COWAL GOLD MINE EXTENSION MODIFICATION

Responses to Submissions

January 2014

Figure 3: Observed and Modelled Groundwater Heads for Transient Calibration in May 2010

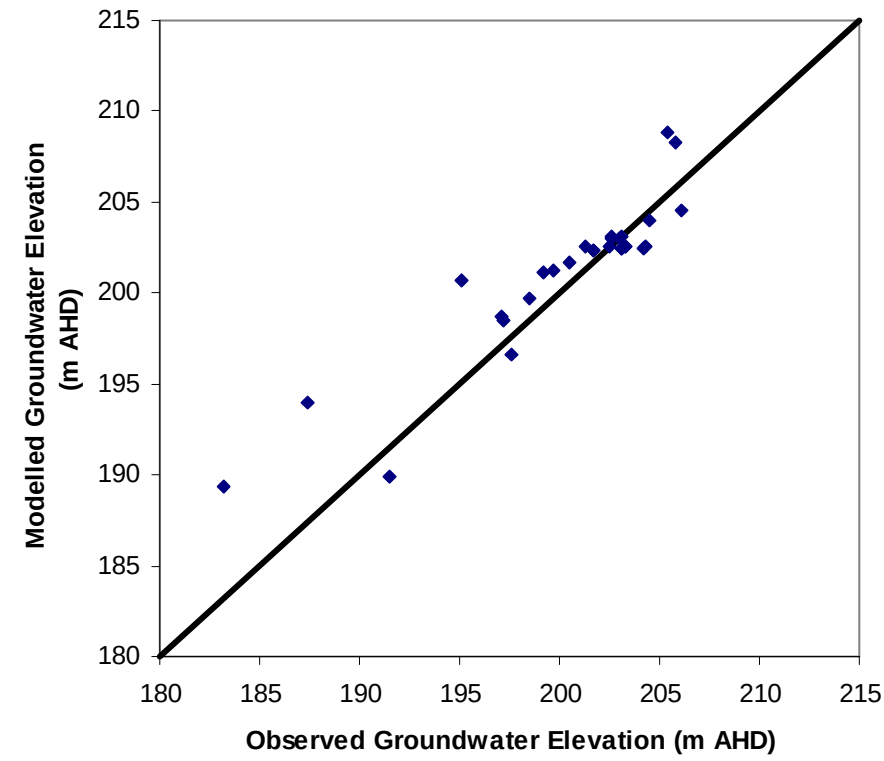
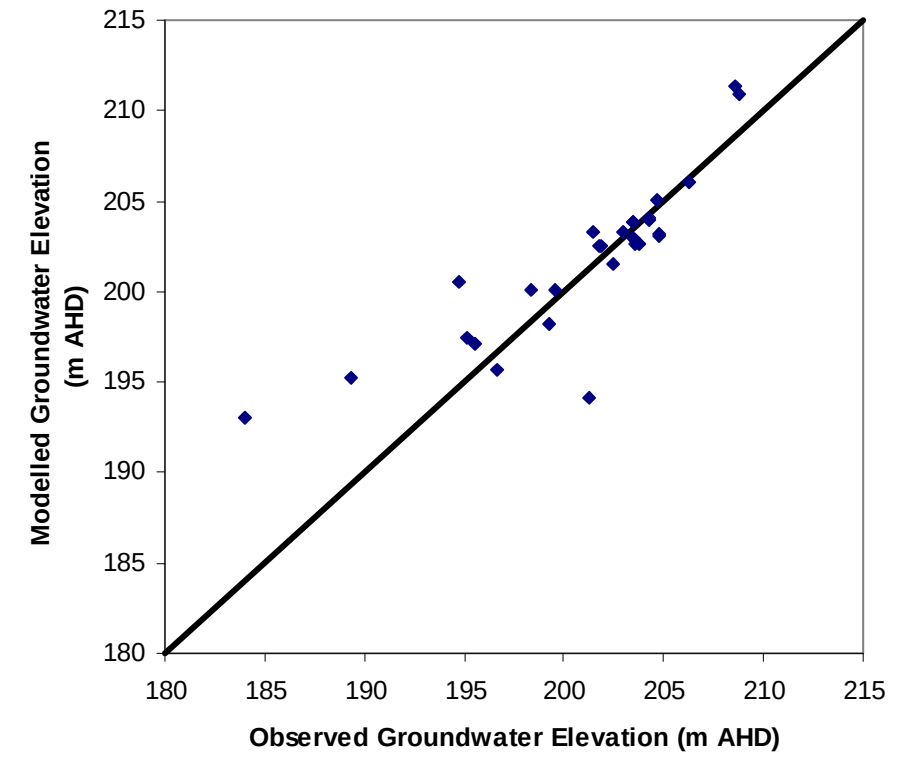
Groundwater Modelling	
<i>Storage coefficient sensitivity analysis was not conducted for the site model.</i>	Coffey Geotechnics reviewed the effect on model outputs (i.e. pit inflows and groundwater drawdown) due to changes in the modelled storage coefficients during calibration of the mine site model. The calibration demonstrated that model outputs were significantly less sensitive to variation in specific storage than to variation in hydraulic conductivity. Therefore, horizontal and vertical hydraulic conductivity were considered in the mine site model sensitivity assessment for the Modification, which found (Appendix A of the EA): • The extent of groundwater drawdown in the hydrogeological units increases, and drawdown associated with ML1535 saline supply borefield increases, however, drawdown greater than 2 m would remain within ML 1535. • Groundwater inflows to the open pit of up to 670 cubic metres per day (m³/day) and 740 m³/day are predicted between 2013 and mine closure for, respectively, the increased vertical hydraulic conductivity simulation and the increased horizontal hydraulic conductivity simulation (compared to 600 m³/day for the basecase). The effect of varying the storage coefficient would result in less variation in predicted groundwater inflows and drawdown (i.e. in comparison to the basecase) than the variation associated with the changes to horizontal and vertical hydraulic conductivity presented in Appendix A to the EA. Actual groundwater inflows to the open pit would continue to be monitored by monitoring of pumping rates from the in-pit sumps and monitoring of water extraction from vertical de-watering bores. In addition, based on the recommendations of Coffey Geotechnics (2013), Barrick would continue groundwater monitoring within ML1535 to validate the results of the predictive groundwater modelling conducted for the Modification (Section 4.1.3 of the EA).

NSW OFFICE OF WATER (Submission ID 81)	
Although the review found the models to be Class 3 with some elements of Class 2, and deemed fit-for purpose, several model deficiencies can be drawn from the review: • A statistical measure of fit for calibration of the mine site model was not included. • Predictive uncertainty has not been quantified for both models, and is addressed by way of general comments only. The mine site model does not provide a robust representation of the calibration results to understand whether it is sufficiently calibrated.	<u>Calibration Statistics – Mine Site Groundwater Model</u> Additional analysis of the mine site groundwater model calibration statistics has been undertaken by Coffey Geotechnics, and is provided as Attachment A to this Responses to Submissions document. Two critical periods of the transient calibration were selected for statistical analysis: • May 2010 – prior to Lake Cowal becoming inundated; and • December 2012 – the end of the transient calibration period. The Scaled Mean Sum of Residuals (SMSR) for the May 2010 results is 5.3% and the SMSR for the December 2012 results is 4.9%, and therefore, Coffey Geotechnics consider that the mine site groundwater model meets the Australian Groundwater Modelling Guidelines recommended SMSR requirement. <u>Predictive Uncertainty – Mine Site Model</u> The model sensitivity analysis presented in Section 5.4.2.5 of Appendix A of the EA quantifies the uncertainty associated with varying key aquifer parameters for the predictive groundwater modelling. Two sensitivity scenarios were simulated, as follows (Appendix A of the EA): • Increasing the vertical hydraulic conductivity of all units by a factor of two. This potentially increases the vertical leakage of groundwater from Lake Cowal, thereby providing an indication of the sensitivity of assessment of impacts on Lake Cowal. • Increasing the horizontal hydraulic conductivity of all units by a factor of two. This results in increased inflows to the open pit and groundwater drawdown, providing an indication of the sensitivity of assessment of impacts on groundwater levels. As described above, groundwater inflows to the open pit of up to 670 m³/day and 740 m³/day are predicted between 2013 and mine closure for, respectively, the increased vertical hydraulic conductivity simulation and the increased horizontal hydraulic conductivity simulation (compared to 600 m³/day for the basecase), and increased drawdown was predicted (compared to the basecase) however drawdown greater than 2 m would remain within ML 1535 (Appendix A of the EA). Actual groundwater inflows to the open pit would continue to be monitored for the Modification by monitoring of pumping rates from the in-pit sumps and monitoring of water extraction from vertical de-watering bores. Based on the recommendations of Coffey Geotechnics (2013), Barrick would continue groundwater monitoring within ML1535 to validate the results of the predictive groundwater modelling conducted for the Modification (Section 4.1.3 of the EA). <u>Predictive Uncertainty – Bland Creek Palaeochannel Groundwater Model</u> The model sensitivity analysis presented in Section 7.1.3 of Appendix A of the EA quantifies the uncertainty associated with varying key aquifer parameters for the predictive groundwater modelling. The sensitivity of modelled groundwater levels to changes in key aquifer parameters was compared to modelled water levels (at groundwater monitoring bores GW036553, GW036597, and GW036611) for the following scenarios (Appendix A of the EA): • vertical conductivity (Kv) of the Lower Cowra Formation 10% lower than the calibrated value;

Figures 3 and 4 show modelled and observed groundwater heads for the transient groundwater flow calibration at those two times, respectively. The SMSR for the May 2010 results (Figure 2) is 5.3% and the SMSR for the December 2012 results (Figure 3) is 4.9%.
